# IEC/IEEE 60802 internal LAN connection model

## Interface naming

Lukas Wüsteney,  
Stephan Kehrer, Hirschmann Automation and Control GmbH

# Current state in IEC/IEEE 60802 D1.4

Figure 21 – IA-station example with IETF interfaces

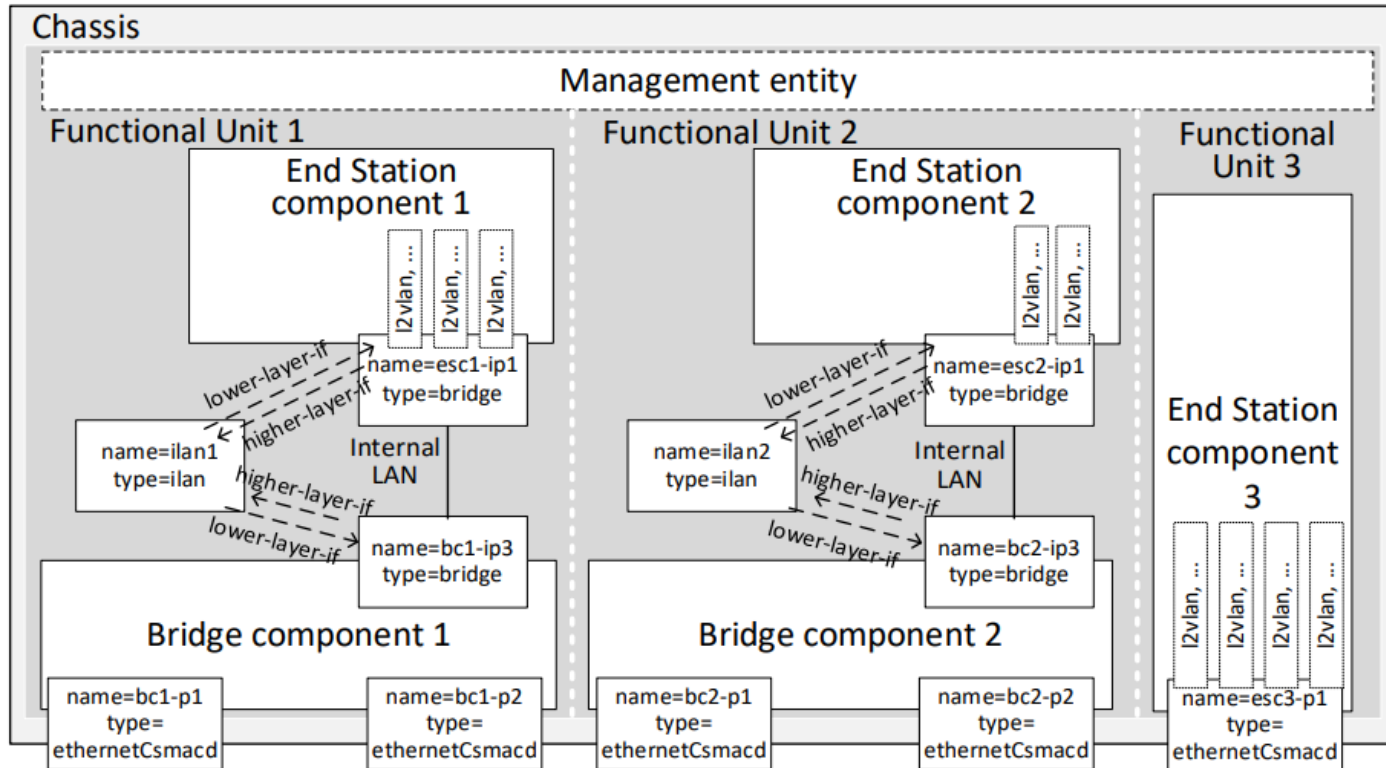
- IETF Interfaces of type I2vlan are used to allow late binding of IA-station applications to the configured VLANs and priorities.
- The naming of these interfaces follows a convention defined in IEC/IEEE 60802 to allow the required translations for VLAN-ID and PCP values
- The interface naming scheme is as follows:  
 $60802- <TrafficType> -pcp <PCPvalue> -vid <VIDvalue> [-R]$

Figure 21 – IA-station example with IETF interfaces

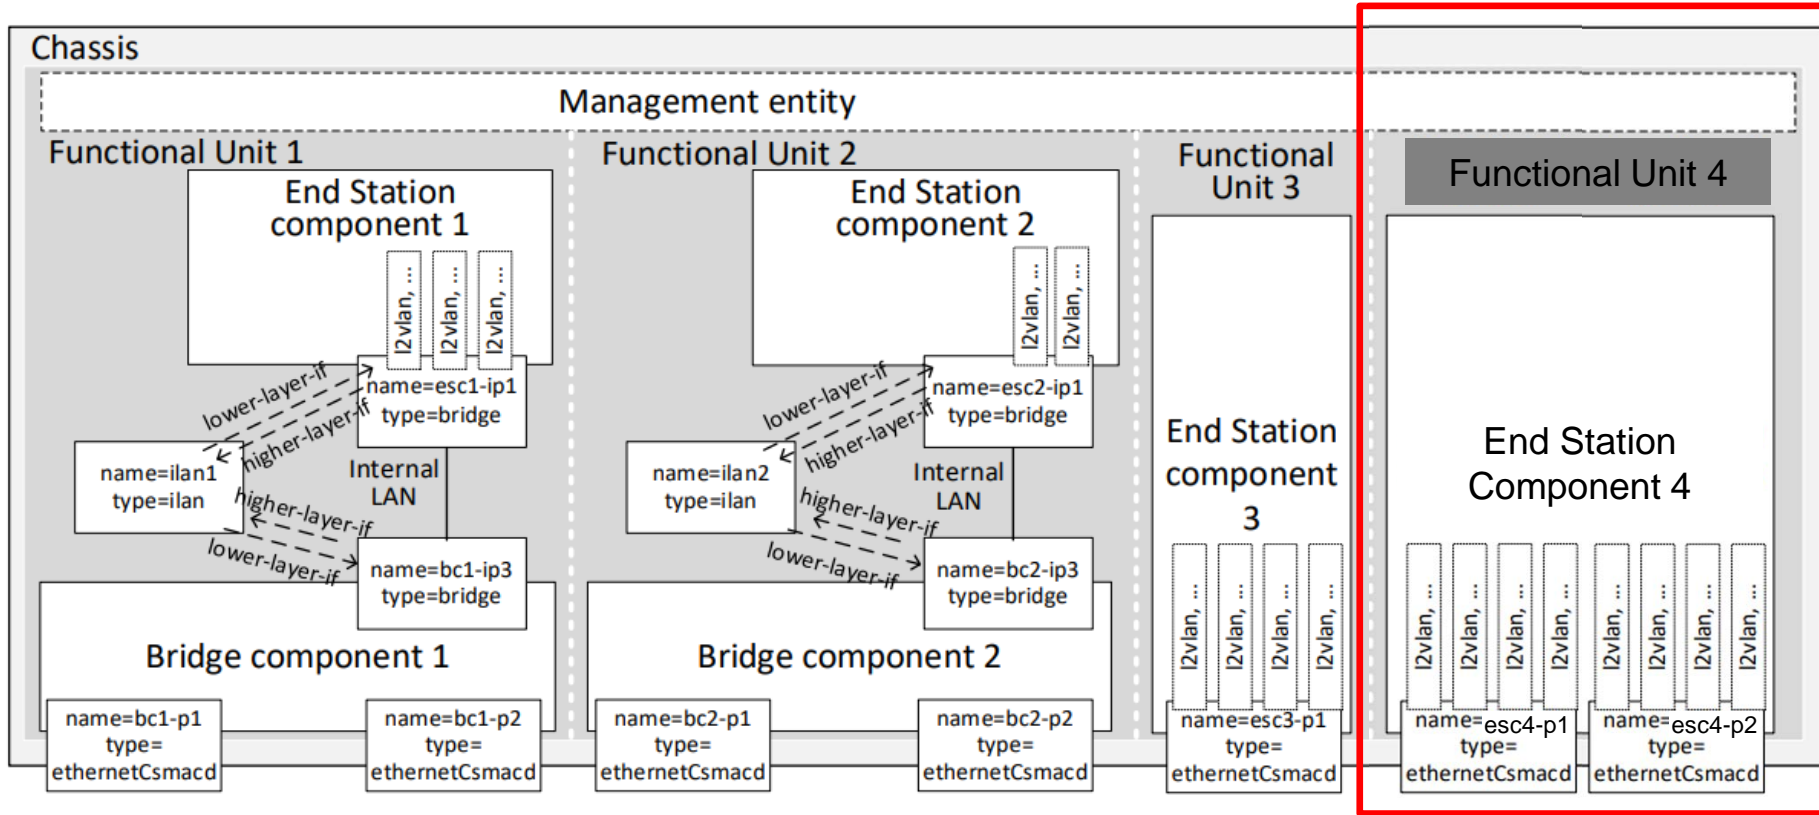
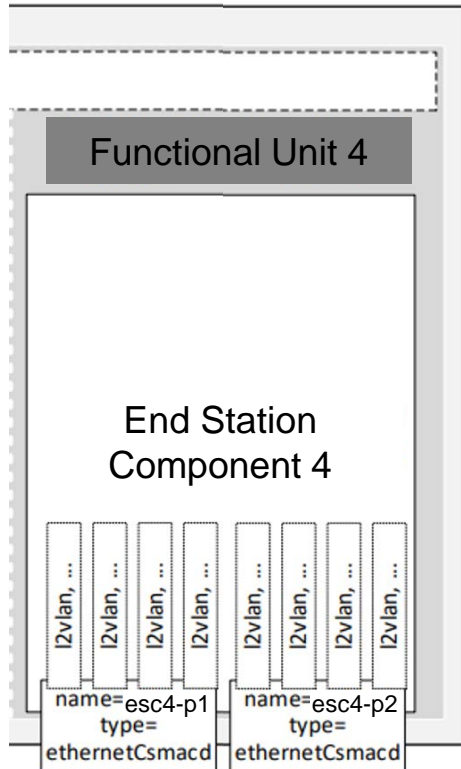
- **But:** End Station Components can have multiple ports, without a Bridge component (new functional unit 4)
- The naming of IETF Interface for the physical interface is unique, but what about the I2vlan interfaces?

- Each port is connected to a different physical network
- Application reads a sensor in one network and writes an actor in the other network.
- Both is asynchronous cyclic traffic, and both use VLAN 100.
- Network Management / CNC configures two I2vlan interfaces according to the IEC/IEEE 60802 naming scheme:  
*60802-asynchronous-cyclic-pcp4-vid100*
- Each of the two I2vlan interfaces is either assigned to esc4-p1 or esc4-p2
- **Problem:**
  - How to differentiate between the different physical ports from the application or network management?

- **Proposal:** Add the physical interface name to the naming scheme for the virtual interfaces  
*60802-asynchronous-cyclic-interface-pcp4-vid100*
